Site Plan Review

Reviewed for compliance with City Ordinance, Building and Fire Codes
Conditions and mark-ups noted throughout plan set must be addressed prior to final approval

City of Rochester Hills, Oakland County, Michigan SITE PLAN DOCUMENTS

Marketplace of Rochester Hills 3900 Industrial Dr.

SHEET
Boundary - Topographic -
Tree Survey

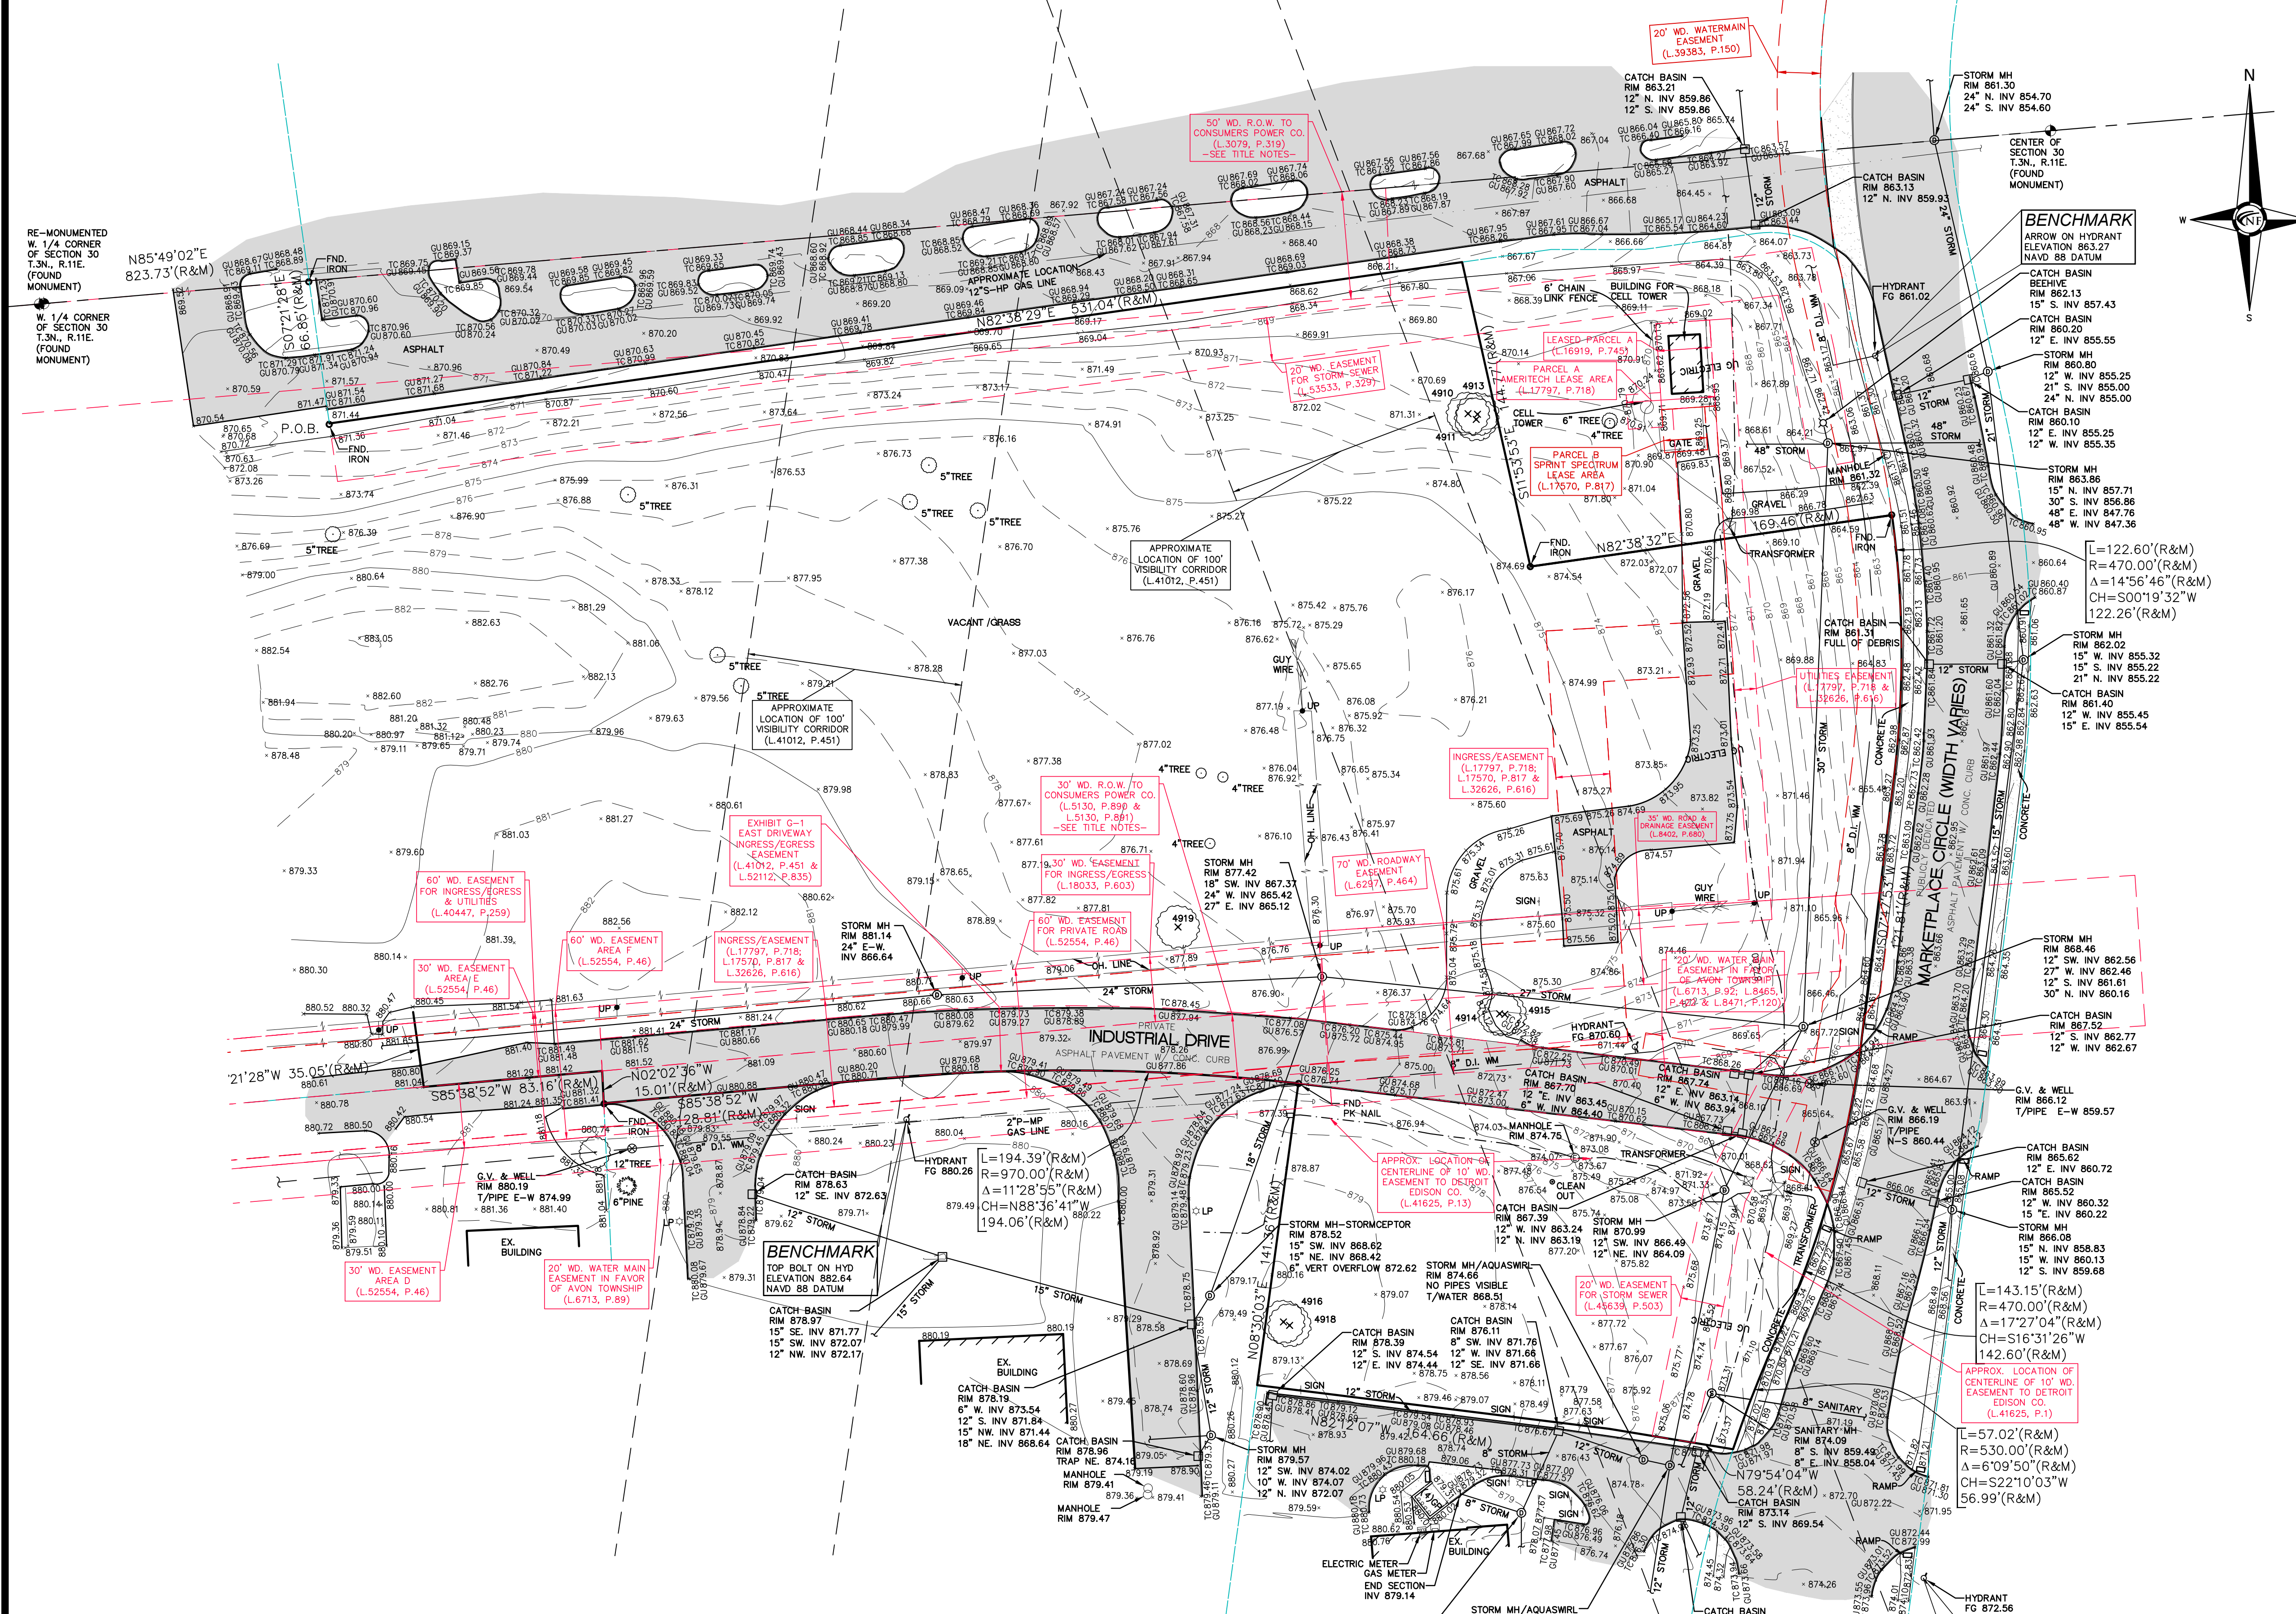
The applicant needs to submit a Land Improvement Permit (LIP) application with engineer's estimate, fee and construction plans to proceed with the construction plan review process.

Understood. Will be completed at time of CD submittal.

SHEET
Stringer Dimension Plan

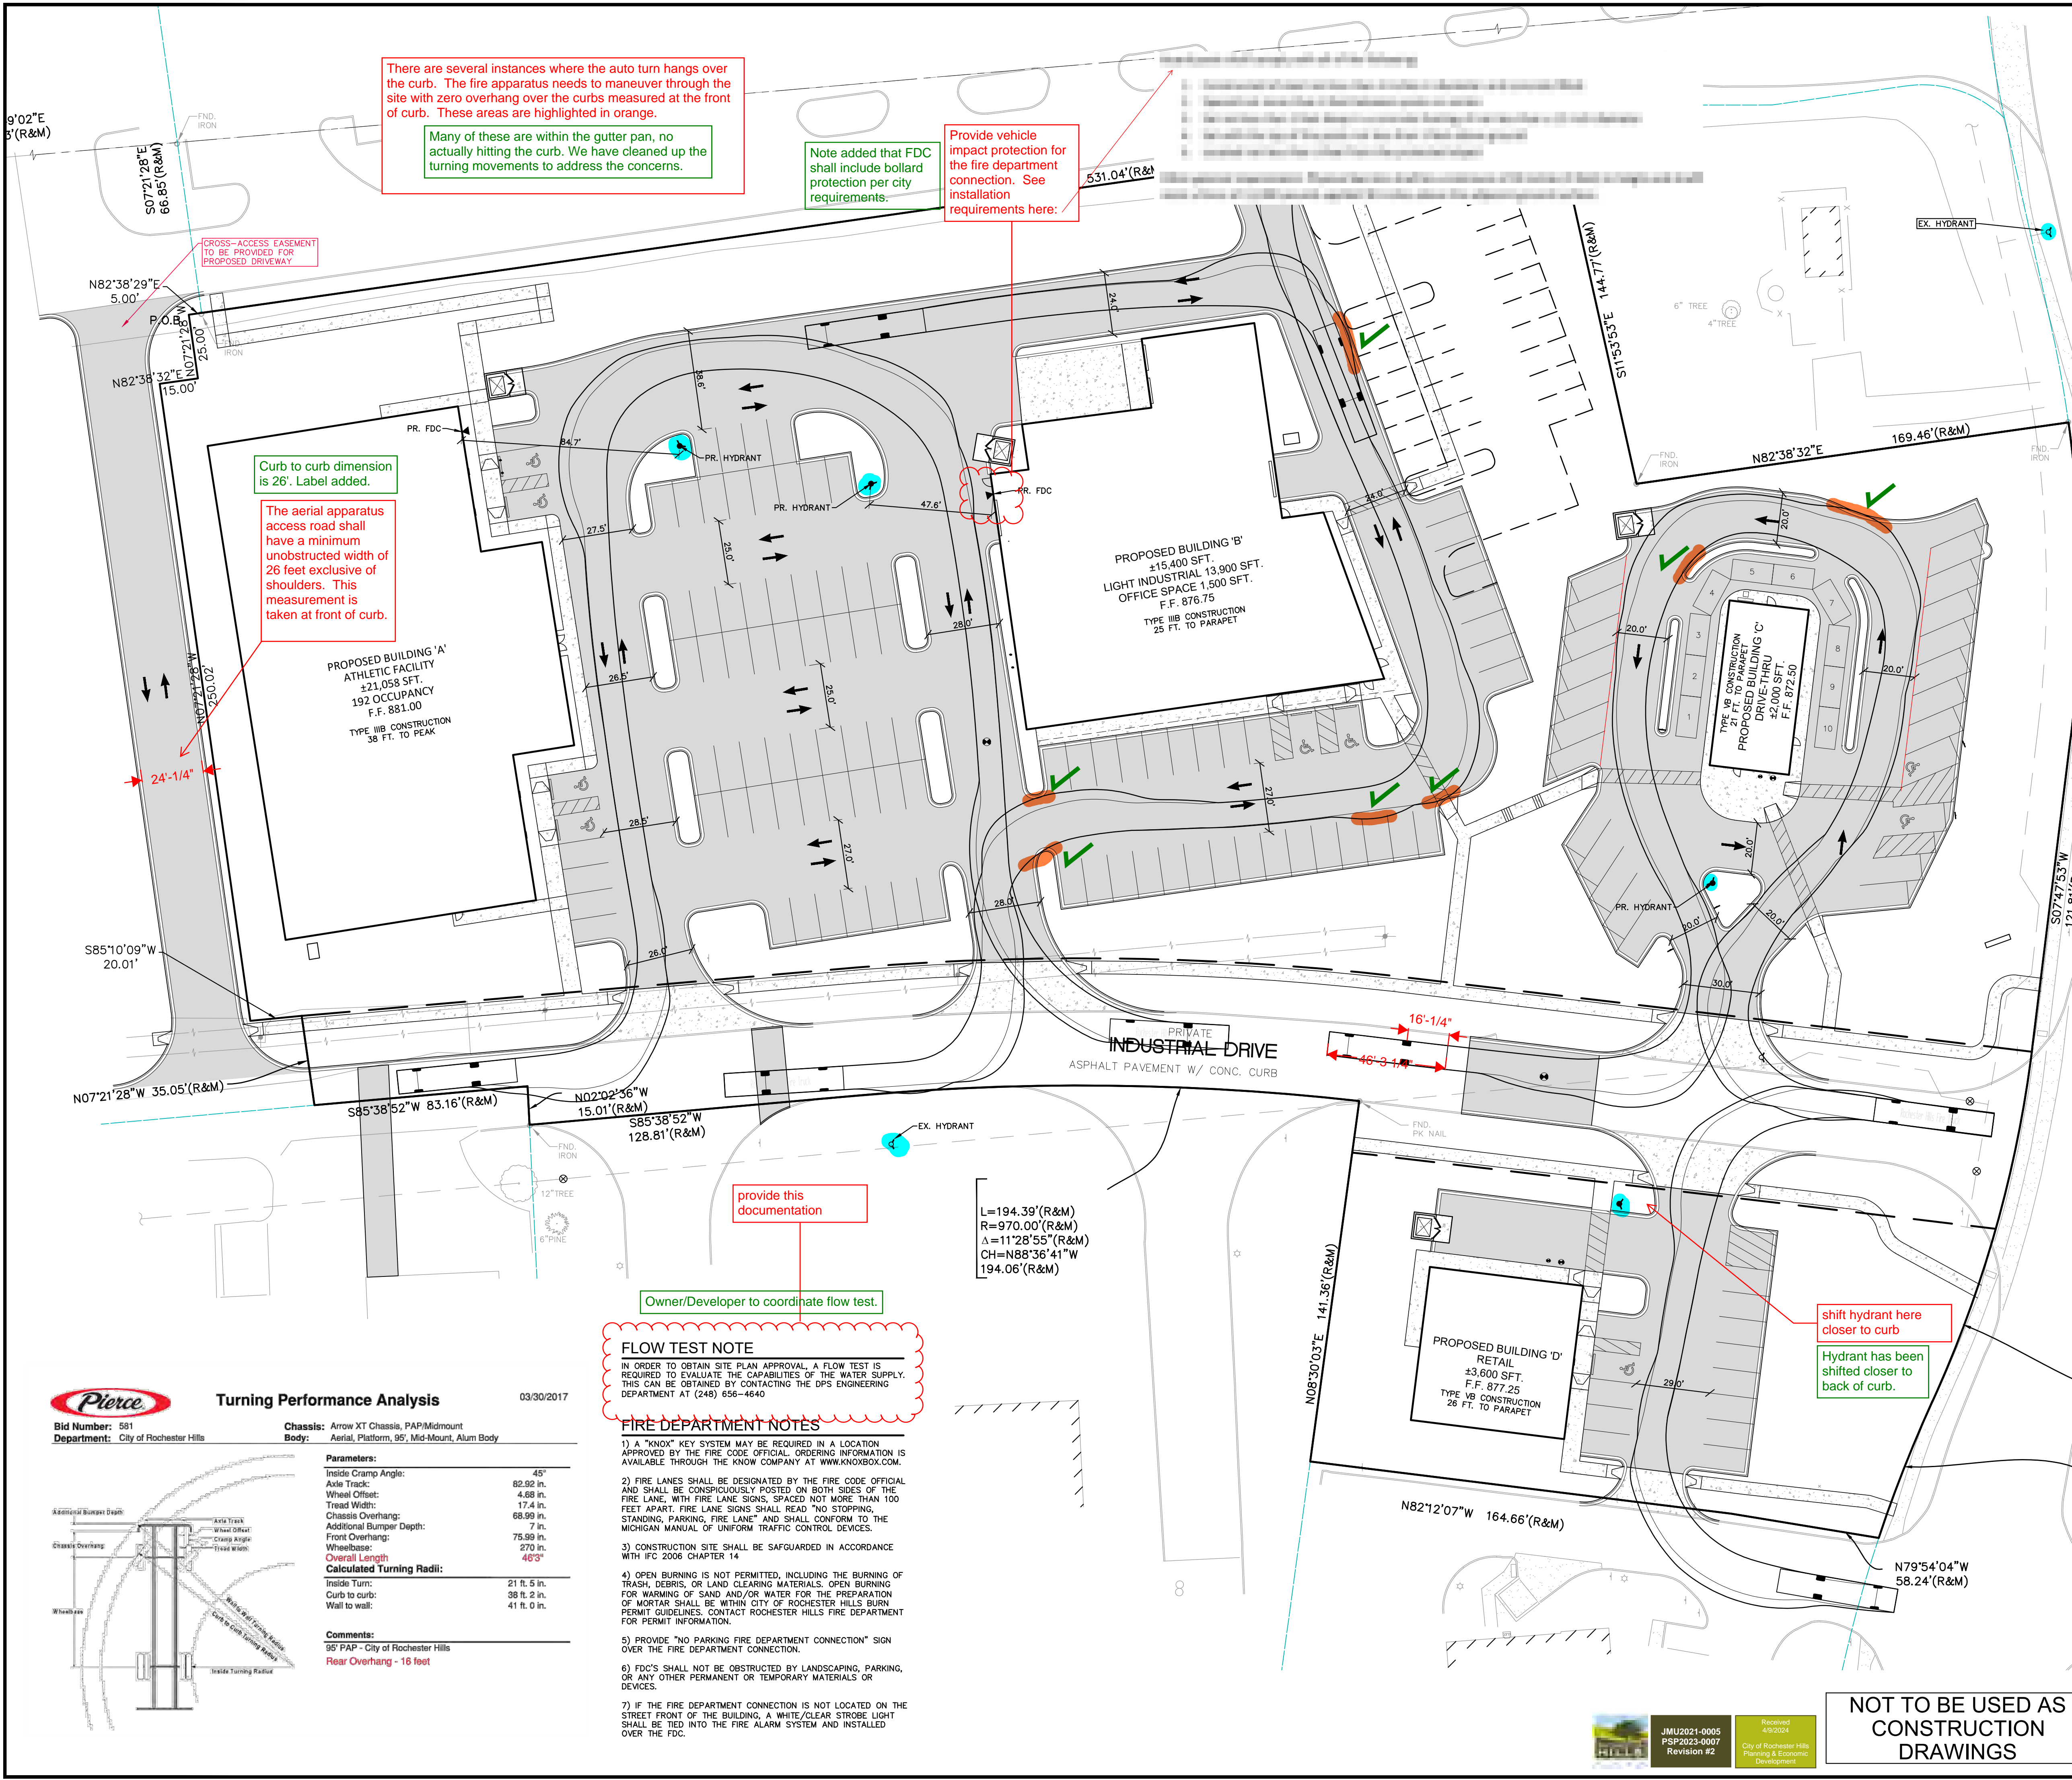
Current assembly parking standard.
Consent judgment does not address assembly parking standards. Staff will support current zoning ordinance calculations being utilized where consent judgment does not provide a specific calculation. Parking calculation changes will be addressed at City Council level.

Noted. No revisions required.
